County Plan No.: GOV LAND 5-144-89; 5-21-93
Project Name: GOV LAND WINGFIELD LAKE
Stormwater Management Facility: JR 017

STORMWATER MANAGEMENT PLAN
LAKE 1
AS-BUILT - WINGFIELD LAKE
GOVERNOR'S LAND
PHASE I
OWNER/DEVELOPER: GOVERNOR'S LAND PARTNERS
JAMES CITY COUNTY, VIRGINIA

Re: Governor's Land - Wingfield Lake
County Plan No. S-144-89
Stormwater Management Facility
County BMP ID Code: JR017

The Environmental Division has reviewed a record drawing and post-construction geotechnical report (ECS # 6221 dated December 31st 2000) as submitted to our office for the above referenced BMP. The record drawing provides as-built information for a large wet pond facility known as Wingfield Lake (Lake 1) as situated in the east-central portion of Governor's Land.

SECTION A-A
LAKE I - DAM DETAILS
N.T.S.

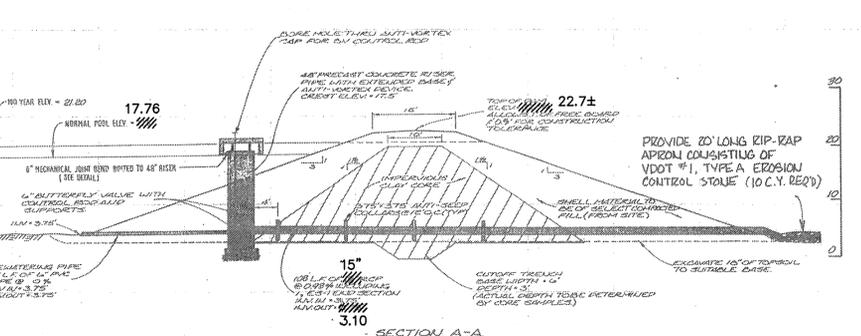
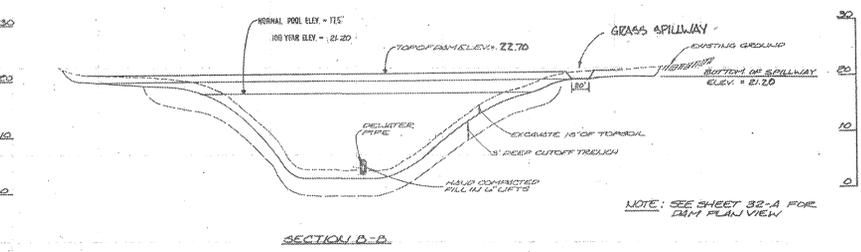
5. Remove small trees and woody vegetation on the downslope embankment. For older facilities which may have established tree growth, we recommend that trees be cut flush to or below ground level and be maintained in that fashion as to not disturb root systems that may already be extensive. Efforts should then be made to reduce tree re-establishment and to replace tree growth with an acceptable low-maintenance grass covering.

6. Clean and remove sediment accumulations, debris and vegetation within the riprap outlet protection pad at the outfall end of the barrel through the dam. Flow out of the facility shall not be obstructed by debris, sediment and vegetation.

WATER QUALITY CONTROL DEVICE DETAIL
N.T.S.

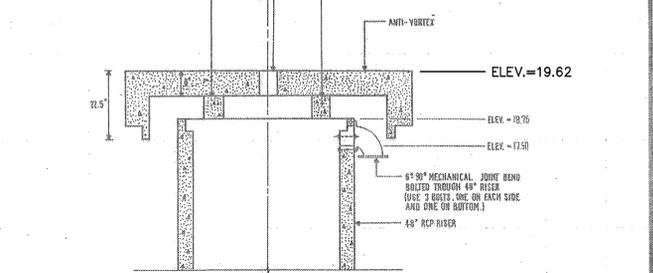
3. Clearly show the crest elevation of the principal flow control structure (riser) on the "water quality control device detail" on the record drawings.

Crest elevation for the riser has been added to the detail sheet of the drawings.

LOT DEVELOPMENT PLAN

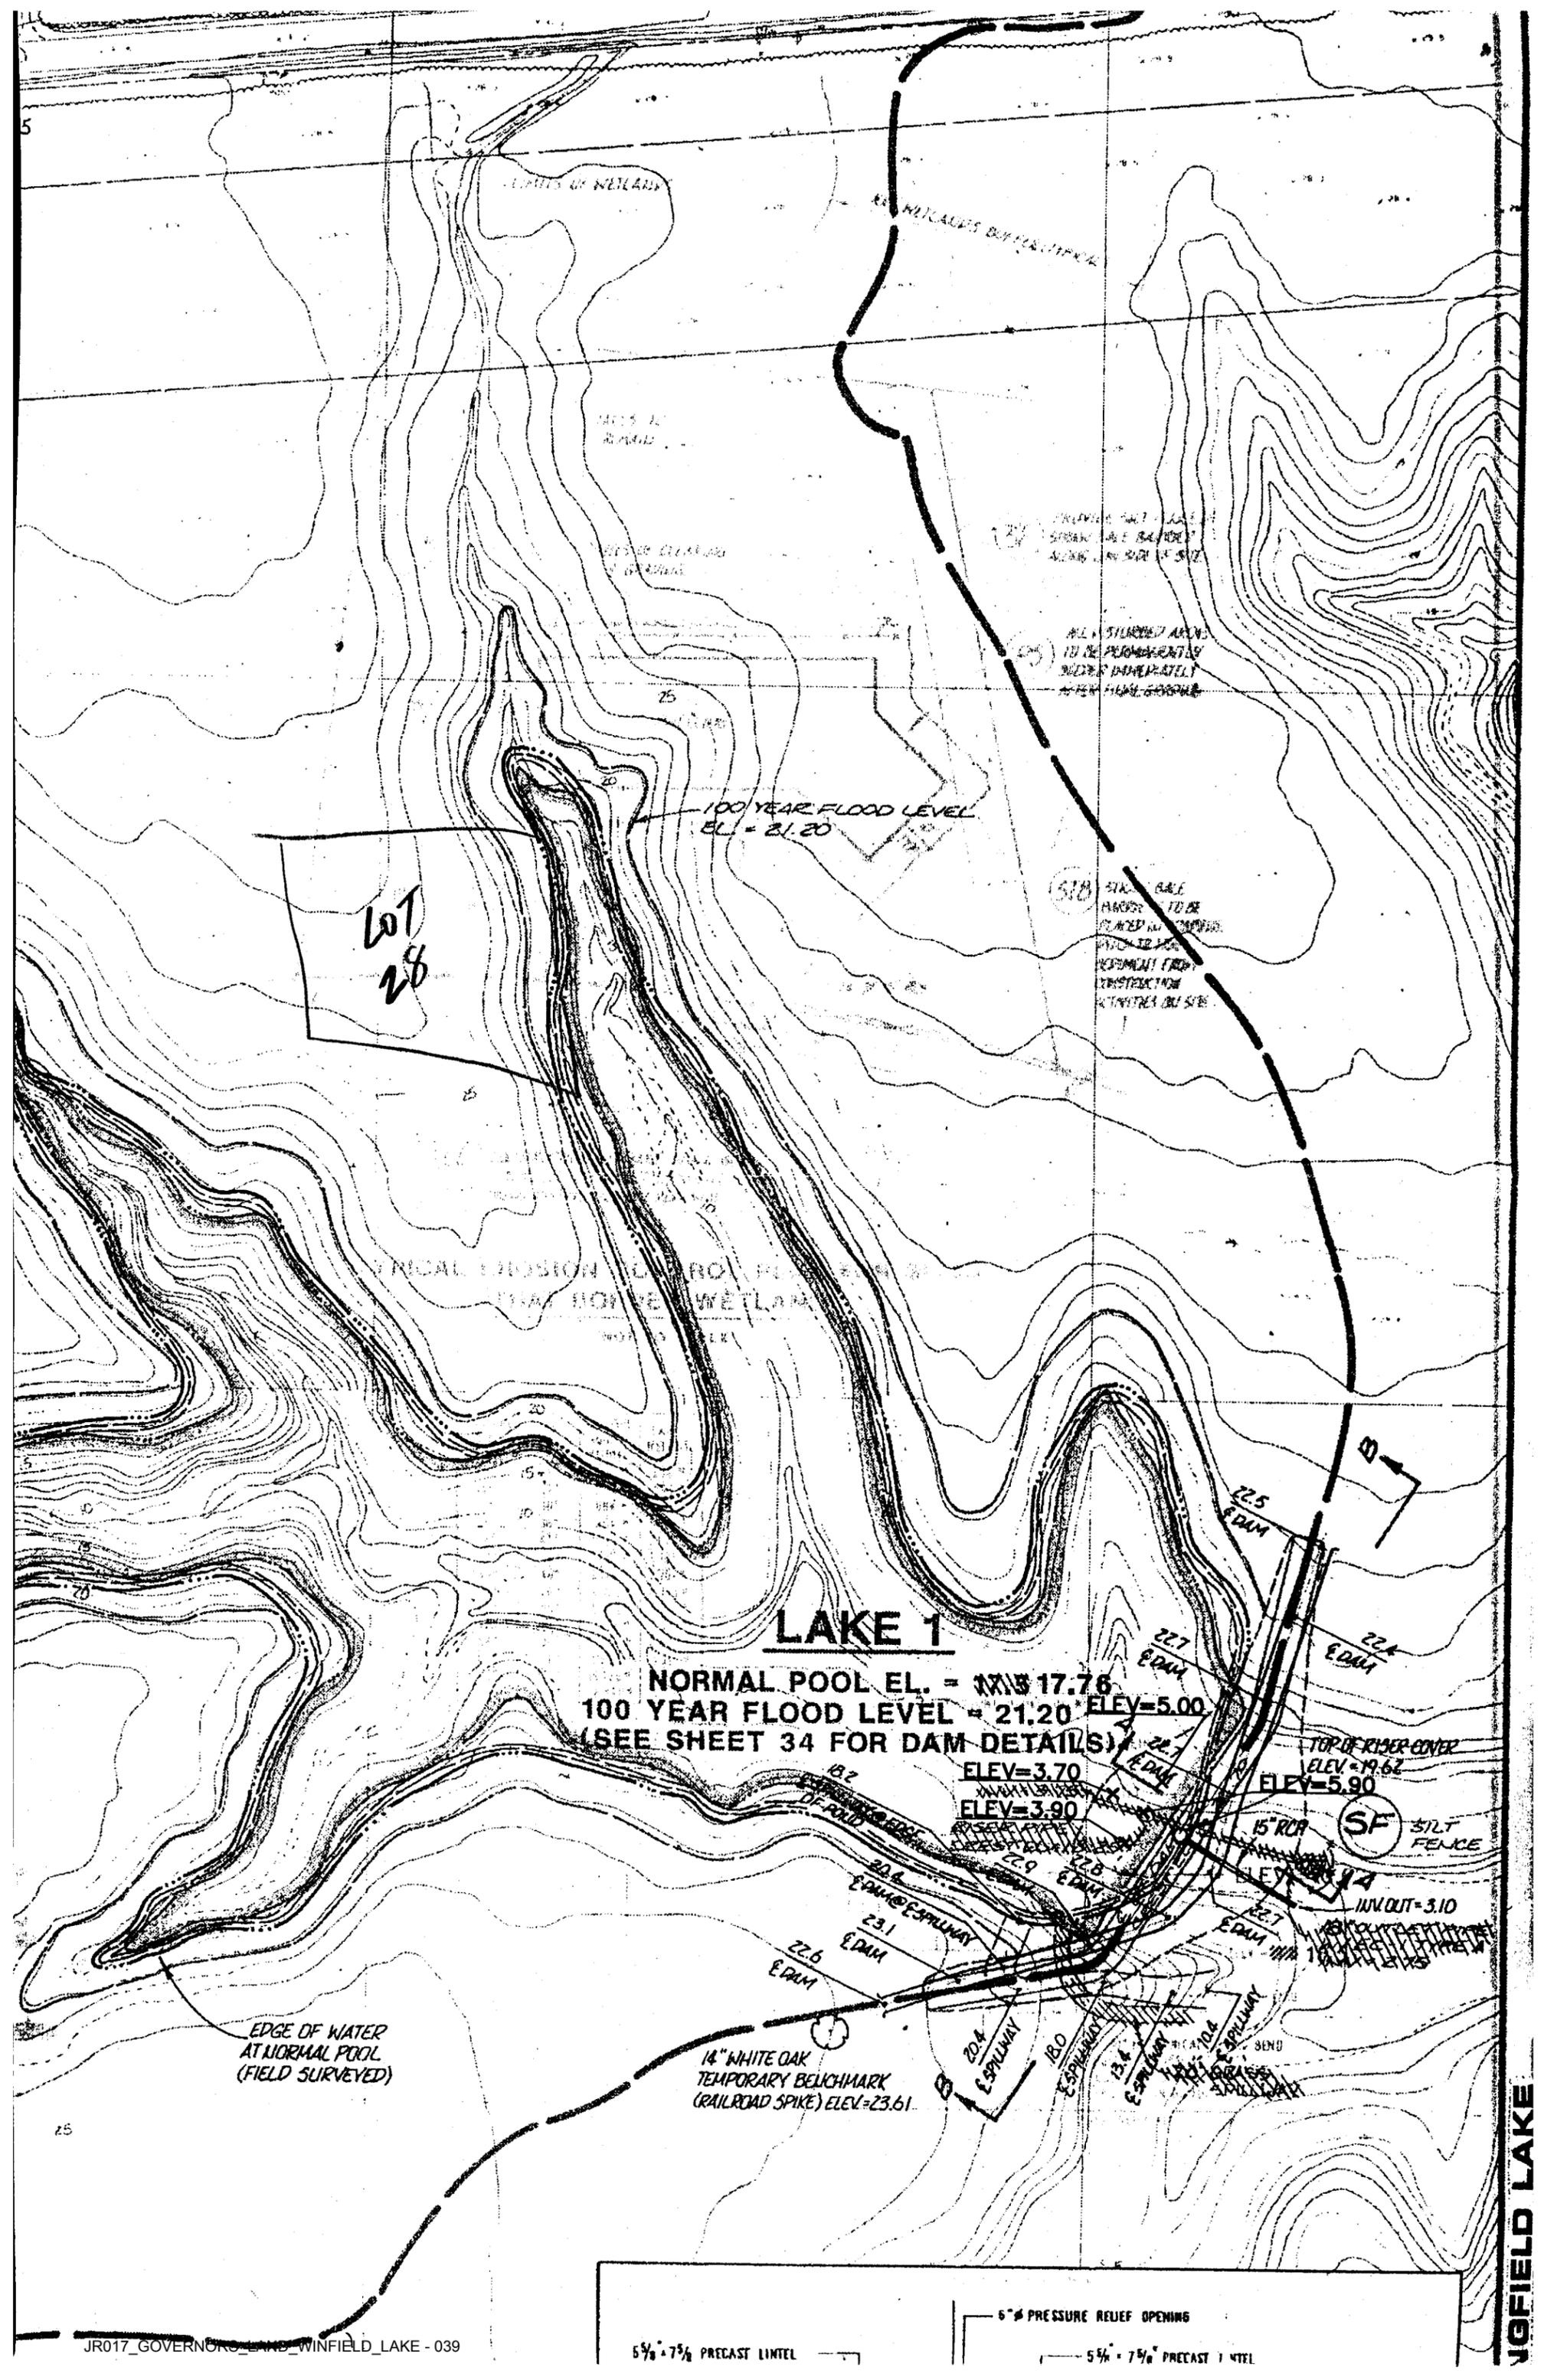
Based on information as available in our record files, it appears the 100-year design high water surface elevation for the adjacent stormwater management facility (Wingfield Lake, County BMP ID Code: JR 017) is at Elevation 21.2. The following information needs to be shown on the proposed single family lot plan: delineate design high water elevation (El. 21.2); delineate the pond setback/buffer (25 ft. minimum) as required per page 38 of the James City County BMP manual; and show proposed grading, especially along the back (west) portion of the lot nearest to Wingfield Lake. (Note: For proper comparison purposes, topographical datum should be consistent between contours and elevations shown on the lot and design high water elevation for the pond.)

However, our concern is the proximity of the proposed residence to the design high water limit of the pond and based on the limit of work shown on the plan, the potential to fill within the existing the stormwater storage volume of the BMP. Grading needs to be shown on the plan to properly make determination of effects to the adjacent stormwater

management facility. If clearing, grading and fill are proposed within the limit of design high water, two alternatives are available. One is to reconfigure the plan to maintain limit of work outside the limit of design high water; or alternatively, in addition to the written request already submitted, submit an engineer's statement (analyses) that the proposed lot fill material will have no adverse impact on the storage volume or function of the stormwater management facility. (Note: It is suggested that if the current footprint is to be maintained without change and grading/fill is proposed within the limit of design high water, then a minimum finished grade spot elevation of El. 23.0 be maintained around the back-west side of the structure a sufficient horizontal distance to provide adequate vertical separation to design high water of the facility.)

THE LOT DEVELOPMENT PLAN HAS BEEN REVISED TO KEEP THE MINIMUM ELEVATION ADJACENT TO THE PROPOSED RESIDENCE AT AN ELEVATION OF 23.0. THIS WILL REQUIRE ABOUT 2' OF FILL TO BE PLACED ON THE POND SIDE OF THE HOUSE. APPROXIMATELY 30 - 40 CUBIC YARDS OF FILL WILL BE PLACED WITHIN THE AREA BETWEEN THE NORMAL POND LEVEL (ELEVATION 17.8) AND THE 100 YEAR POND LEVEL (ELEVATION 21.2). THIS FILL WILL DISPLACE ABOUT 0.1% OF THE 6 AC. POND'S PEAK STORAGE CAPACITY, WHICH WILL HAVE MINIMUM IMPACT ON ITS DESIGNED FUNCTION. IF YOU HAVE ANY QUESTIONS, PLEASE CALL OUR OFFICE AT 890-0837.
